State of Ohio Environmental Protection Agency

**Re: Industrial Storm water Inspection at New Plain City Elementary School.  
Permit No. 4GCD00058\*AG**

Figure 2: Silt fence needs to be repaired

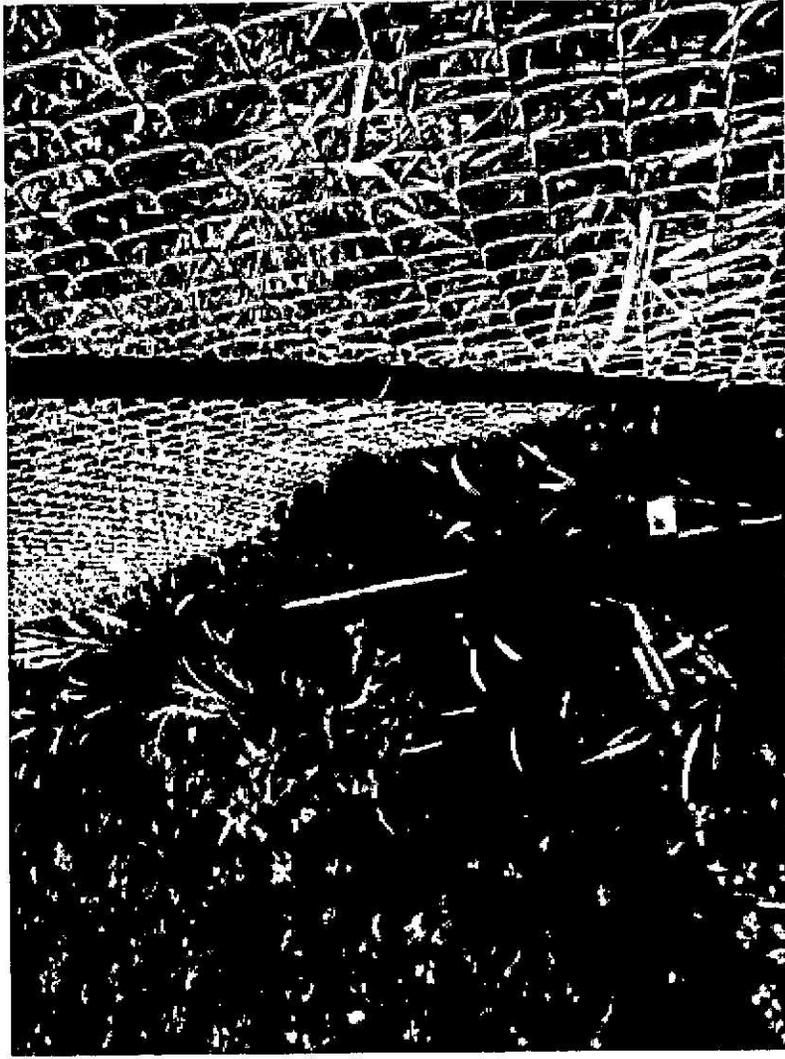
- The silt fence on the west end of the project requires maintenance. Please continue to maintain positive flow of storm water to the impoundments intended for sediment control.
- I noted the majority of the site was currently contained within the excavation of the bio-retention facilities.
